**UNITED STATES DEPARTMENT OF COMMERCE**

**NATIONAL MARINE FISHERIES SERVICE**

November 24, 2014

NOAA's National Marine Fisheries Service (NMFS) Habitat Conservation Division (HCD) has reviewed *Charleston Harbor Post 45 Draft Integrated Feasibility Report and Environmental Impact Statement (Draft EIS)*, dated October 2014 and prepared by the U.S. Army Corps of Engineers (USACE); Draft EIS Appendix H is an Essential Fish Habitat (EFH) Assessment. The Draft EIS examines impacts from deepening and widening the federal channel and turning basins in the Cooper and Wando Rivers, and Charleston Harbor and deepening and lengthening the Entrance Channel oceanward. Draft EIS Section 3.2 provides the project needs and purpose. The needs for the action are transportation delays to container ships and navigational safety. While existing channel depths accommodate vessels with a draft up to 48 feet, the ships are limited to tide windows of approximately two hours per day unless light loaded. Charleston Harbor pilots and the U.S. Coast Guard believe the risk of allisions, collisions, and groundings is unnecessarily high at four locations. The purpose of the project, as stated in the Draft EIS

Figure 1. Comparison of benefit/cost ratio and net dollars generated by three depth alternatives. The Draft EIS does not present full economic evaluations for the other depth alternatives.

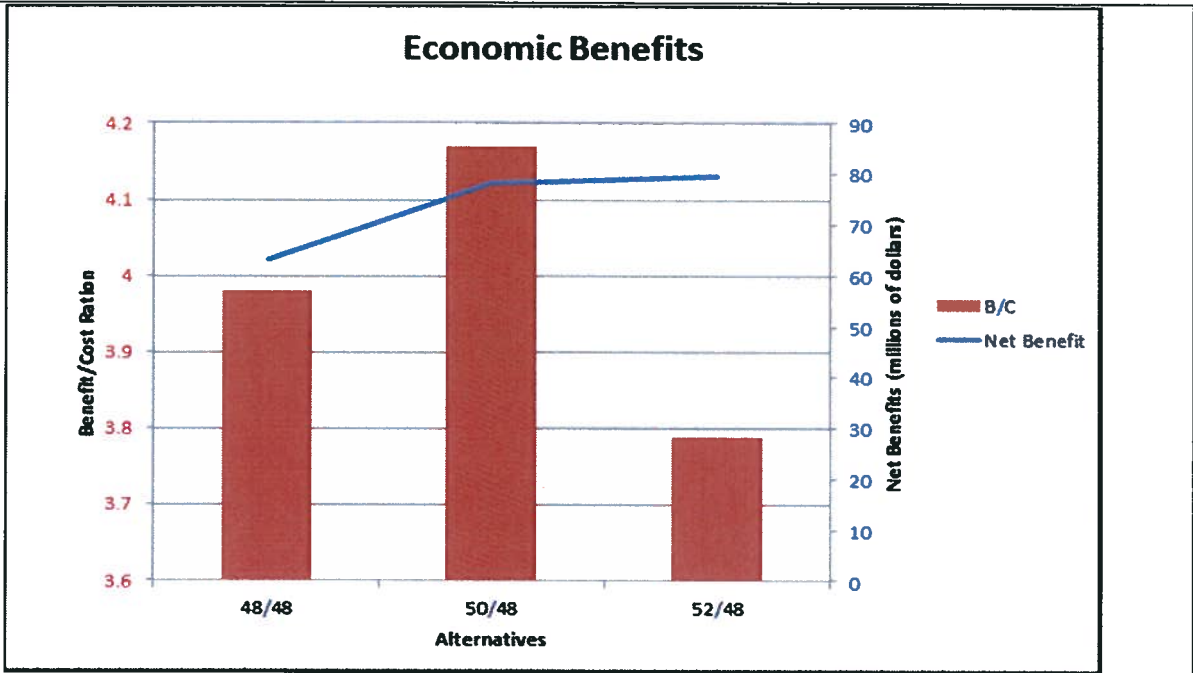
Draft EIS Section 3.6 and Appendix C (Economic Analysis) indicate the annual net benefits forecasted for the LPP, which accrue through reduced transportation costs, exceed those of the NED plan by \$1.8 million (\$79.9 million vs. \$78.1 million). However, as expected, the LPP has a lower benefit-to-cost ratio than the NED plan (Figure 1). The LPP is not the optimum plan economically, and the net annual benefits of the LPP may not differ from those of the NED plan when considering the error normally inherent in such estimates.

- The Final EIS should identify the NED plan as the selected alternative given the lower economic efficiency and higher environmental cost of the LPP.

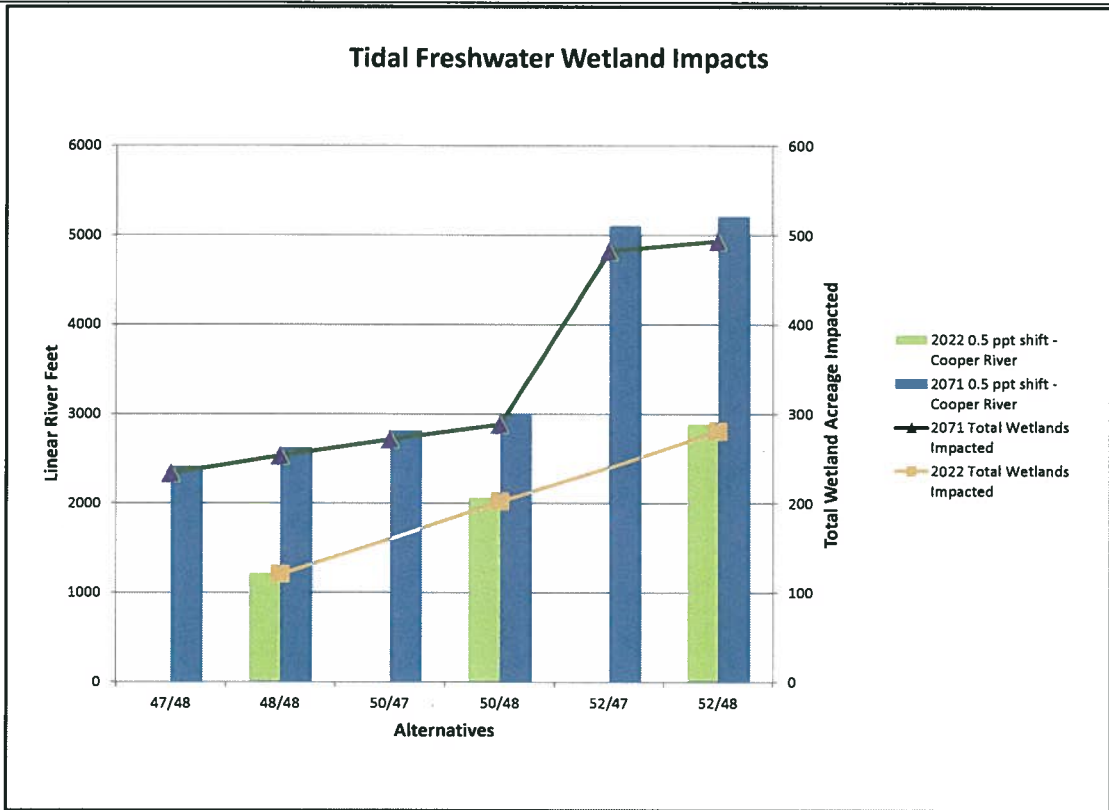
The environmental impacts expected from the LPP significantly exceed those expected from the NED plan. While the expected impacts to offshore habitats from the LPP and NED plan are the same because the Entrance Channel dimensions are the same under these two alternatives, the impacts to wetlands along the Cooper, Wando, and Ashley Rivers from salinity intrusion differ substantially. Draft EIS Appendix L (Wetland Impact Assessment) Table 2 shows the LPP would convert 493.41 acres of tidal freshwater wetlands to brackish wetlands, whereas the NED plan alternative would convert 288.34 acres. In short, to achieve a 2.3 percent gain in benefits, the LPP incurs a 71.1 percent increase in environmental impacts relative to the NED plan.

tidal freshwater marsh and tidal palustrine forests to brackish marsh. As described in EFH Assessment Section 6.0, increases in salinity will alter habitat functions by changing soil chemistry and plant communities. Tidal forested wetlands will be replaced by more salt tolerant emergent wetlands reducing plant diversity and canopy cover and altering faunal use. The acreages of tidal freshwater marshes and tidal forests converting to brackish marsh were forecasted for 2022 (i.e., soon after construction, likely within a year) and 2071 (i.e., 50 years after construction). The only difference between the salinity models used in these forecasts is the 2022 condition has roughly six inches less sea level rise than the 2071 condition. These salinity models are used to predict the location of the 0.5 parts per thousand (ppt) isopleth, which is the most practicable indicator of where tidal freshwater wetlands transition to brackish wetlands. For the Cooper River, the 2022 future without project (FWOP) conditions move the 0.5 ppt isopleth 1,092 feet upriver under the LPP, and the 2071 FWOP conditions move the isopleth 7,039 feet upriver. Figure 2 shows the additional distances the 0.5 ppt isopleth would move up the Cooper River under each alternative. By 2071, the isopleth is expected to be 5,210 feet farther upriver under the LPP, whereas under the NED plan alternative, the isopleth would be 2,996 feet farther up river. As noted in the NEPA section of this letter, impacts under the LPP would be significantly higher than under the NED plan alternative.
